STAFF REPORT
COMMUNITY DEVELOPMENT DEPARTMENT

HEARING DATE: 10/6/2022
 TO: Planning & Zoning Commission
 FROM: Joe Dodson, Associate Planner
 208-884-5533
 SUBJECT: H-2022-0039
 Slatestone Subdivision
 LOCATION: Located at 2707 S. Stoddard Road, in the NE 1/4 of the SW 1/4 of Section 24, Township 3N, Range 1W.

Request for Annexation and Zoning of 5.04 acres of land with the R-8 zoning district and a preliminary plat consisting of 15 single-family building lots and 4 common lots on 4.85 acres in the requested R-8 zoning district, by T-O Engineers.

B. Preliminary Plat (dated: 9/21/2022)

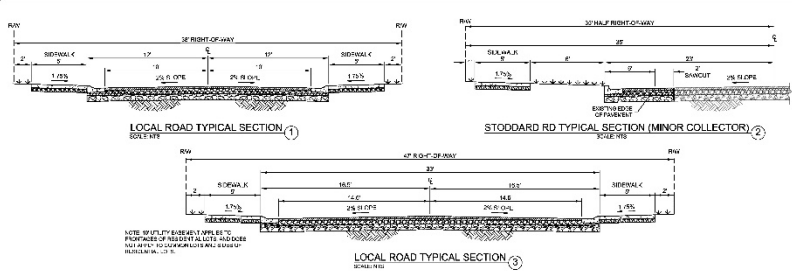
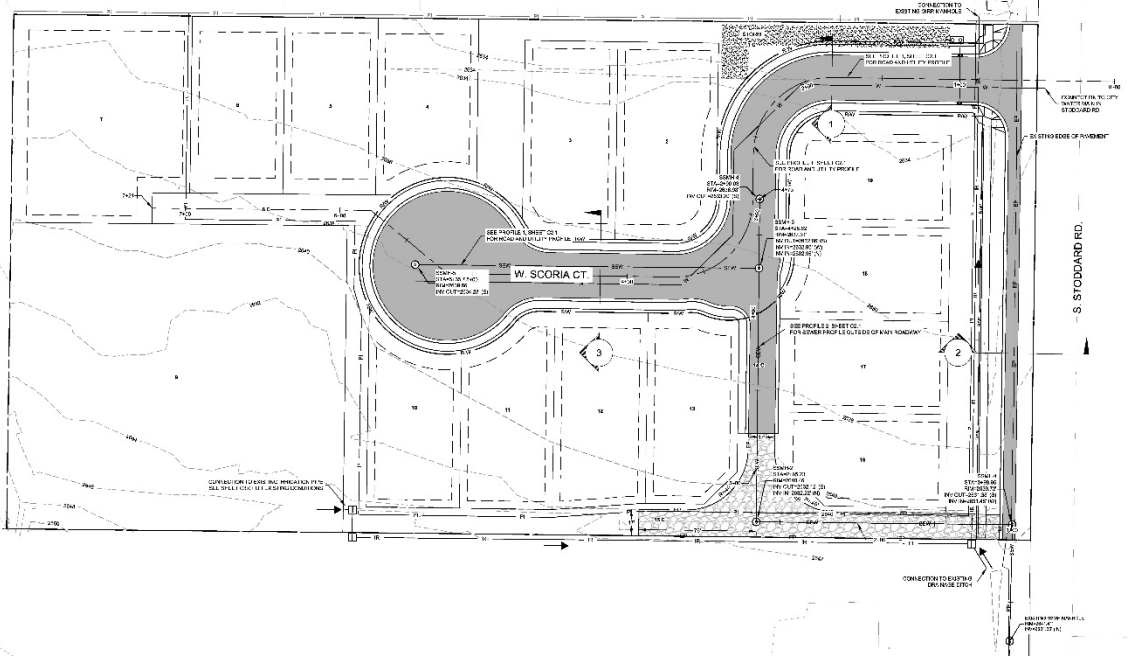
The Applicant is proposing two (2) common drives within the project; one in the southeast corner of the project for access to Lots 16 & 17 and an additional common drive near the northwest corner for access to four lots (Lots 5-7 and Lot 9). Lot 8 common drive appears to comply with all standards outlined in UDC 11-6C-3D. However, the construction of the Lot 14 common drive does not appear to comply as it creates a sidewalk gap on the public street and does not extend 20 feet past the property line for Lot 16. ACHD does not call this out in their staff report but Staff finds that Lot 14 should match Lot 8 in its design and not be a part of the public road network as depicted on the submitted plans. The Applicant should continue the curb, gutter, and 5-foot sidewalk between Lots 13 & 18 consistent with the curve of the public street and mirror the design of the Lot 8 common drive. In addition, the Applicant should extend the common drive 6 feet further to the south to ensure at least 20 feet of frontage for Lot 16. The Applicant should make these revisions with the first final plat submittal.

Staff does have concerns with the proposed micro-paths and sidewalk connection near the common drive at the southeast corner of the site, Lot 14. According to the submitted plans, the micro-path connects to the common drive and utilizes it as a pedestrian pathway. The City does not desire this type of design for pedestrian and vehicles to share the same surface if it can be avoided. Therefore, Staff is recommending 5-foot wide sidewalk be added to the common drive on either side of the common drive for added pedestrian safety. This recommendation will require the 5 feet to be taken from the adjacent lot to the west (Lot 13) or the lots to the east (lots 16-18).

Because the Applicant is placing a sewer main within a common lot, it must have a drivable surface over top for City access. This is shown on the submitted plans but also depicts a hammerhead type turnaround that is not required by the City. Because it is not required, Staff recommends removing the western piece of this turnaround to square up the southeast corner of Lot 13 and provide more area that can be landscaped behind Lot 13 up to the required 20-foot wide sewer main easement.

According to satellite imagery, the subject site contains an irrigation ditch along the southern boundary. The submitted plat depicts this irrigation ditch but does not show it on the subject property. In accord with UDC 11-3A-6B.3, if the irrigation ditch is on the subject property, the Applicant is required to pipe the ditch.

2. The preliminary plat included in Section VII.B, dated September 21, 2022, shall be revised as follows prior to submitting for Final Plat approval:
 - a. Show all linear open space to be at least 20 feet wide consistent with UDC 11-3G-3 standards or lose one of the buildable lots in lieu of a larger and centralized open space lot with a commensurate amenity that is code compliant.

- b. Direct lot access to S. Stoddard Road is prohibited in accord with UDC 11-3A-3.
 - c. Correct the plat to show curb, gutter, and 5-foot attached sidewalk between Lots 13 & 18 consistent with the curve of the public street

- d. Show the common drive on Lot 14 to be six (6) feet further to the south to ensure at least 20 feet of frontage for Lot 16.
 - e. Add a 5-foot wide sidewalk to either side of the Lot 14 common drive to connect it to the local street sidewalk and proposed micro-path in Lot 15 common lot.

- f. Remove the western piece of the turnaround up to the required 20-foot wide sewer main easement shown in Lot 15 to square up the southeast corner of Lot 13 and provide more area that can be landscaped behind Lot 13.

- g. Depict the required 10-foot wide multi-use pathway along S. Stoddard Road and place it at least four (4) feet outside of the ultimate curb and gutter location to allow for landscaping on both sides of the pathway. Prior to the City Engineer's signature on the final plat for Phase 1, a 14-foot wide public pedestrian easement shall be submitted to the Planning Division and recorded for the multi-use pathway as required by the Park's Department, unless ACHD requires ones.

**PRELIMINARY PLAN FOR:
 SLATESTONE SUBDIVISION
 SITEPLAN**

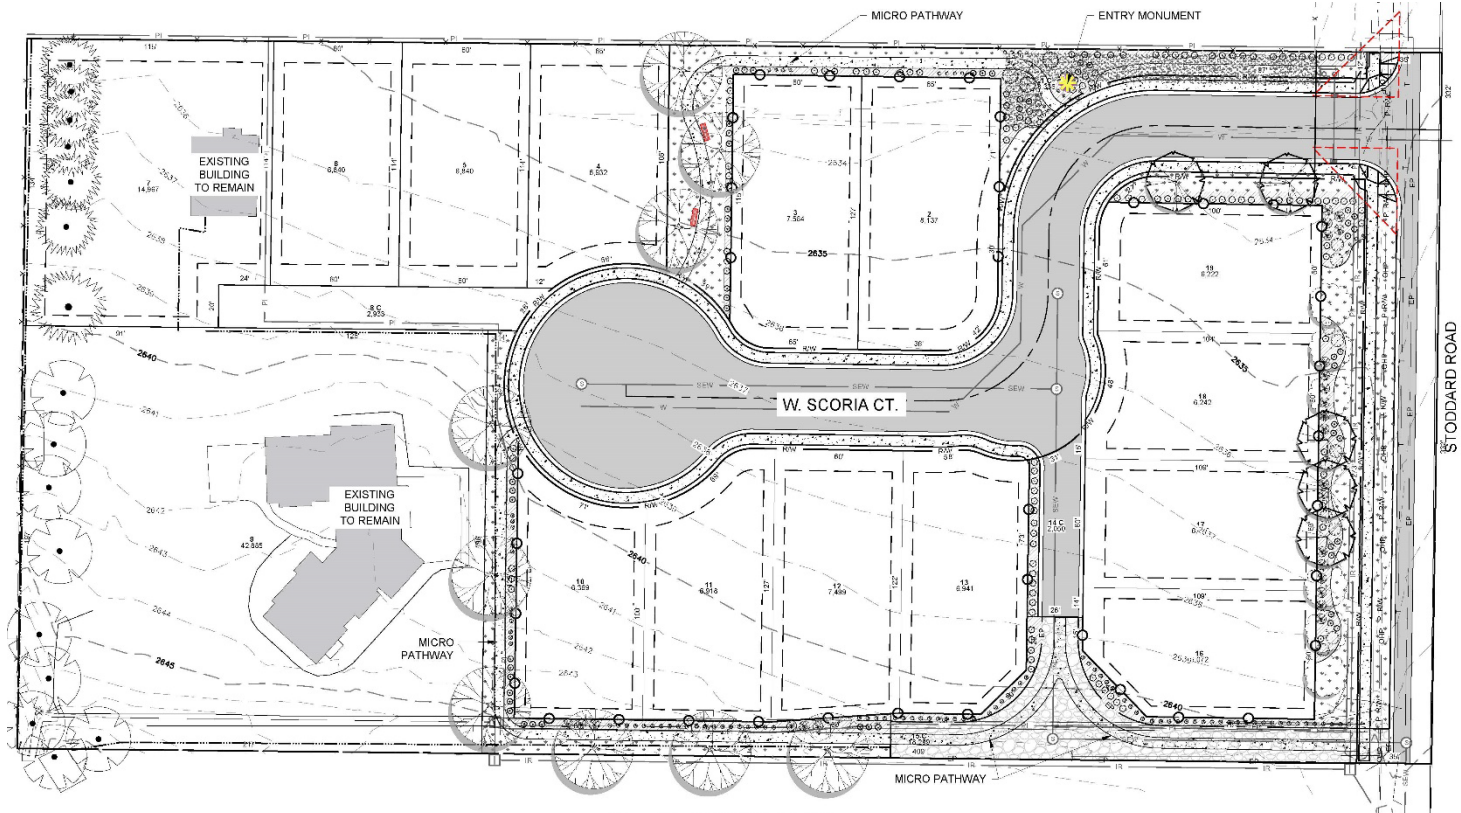
According to the submitted plat and landscape plan, the proposed detached sidewalk along Stoddard is shown within ACHD right-of-way but at least 6 feet from the new curbing and added pavement proposed with this project, consistent with the UDC. With the requirement of the multi-use pathway along Stoddard, the Applicant may be required to submit a public access easement; the Applicant should continue working with ACHD to determine who will maintain the pathway based on its location within the ROW.

The Applicant is showing a common lot along S. Stoddard that is at least 20-feet in width and located wholly outside of the additional right-of-way dedication required by ACHD consistent with code requirements. The Stoddard landscape buffer is depicted with 9 trees, sod, and landscape beds with shrubs, consistent with UDC 11-3B-7. The Applicant is also showing landscape beds on both sides of the new local street connection to Stoddard with two trees on the south side of this entrance adjacent Lot 19. All street landscaping complies with UDC requirements.

As discussed, the Applicant has proposed linear open space and micro-paths around and through the development. These areas should be landscaped in accord with UDC 11-3B-12 with trees at least every 100 linear feet and include other vegetative ground cover. According to the submitted landscape plans, the Applicant is proposing trees in excess of code requirements with landscape beds, shrubs, and sod throughout. Staff finds the proposed landscaping meets or exceeds code requirements. Staff notes that with the recommended revisions to widen some areas to at least 20 feet in width, additional trees and vegetative ground cover should also be added to remain compliant with UDC 11-3B-12 OR lose one of the aforementioned buildable lots in order to provide more usable open space for the development.

*According to the revised landscape plans, the Applicant is proposing to keep the existing 6-foot vinyl privacy fencing along the perimeter of the property compliant with code. The Applicant is also showing 6-foot vinyl privacy fencing along the sides and rear boundaries of the building lots adjacent to the proposed micro-paths. This fencing is not code compliant as these linear open space areas are set behind building lots and are not visible from end-to-end. **Therefore, the Applicant should revise the landscape plans to depict open vision fencing or semi-private open vision fencing consistent with UDC 11-3A-7 adjacent to Lots 2, 3, 10-13, & 16.***

3. The landscape plan included in Section VII.C, dated September 22, 2022, shall be revised as follows prior to submitting for Final Plat approval:
 - a. Show all linear open space to be at least 20 feet wide consistent with UDC 11-3G-3 standards or lose one of the buildable lots in lieu of a larger and centralized open space lot with a commensurate amenity that is code compliant.

- b. Make the necessary revisions to the landscape plans to match the plat revisions noted above in VIII.A2.
 - c. Add additional trees along micro-path north of Lots 2 & 3 to remain consistent with UDC 11-3B-12 following the widening of this area to 20 feet.

- d. Depict open vision fencing or semi-private open vision fencing consistent with UDC 11-3A-7 adjacent to Lots 2, 3, 10-13, & 16 (refer to Figure 1 in UDC 11-3A-7 for depictions of fencing types).
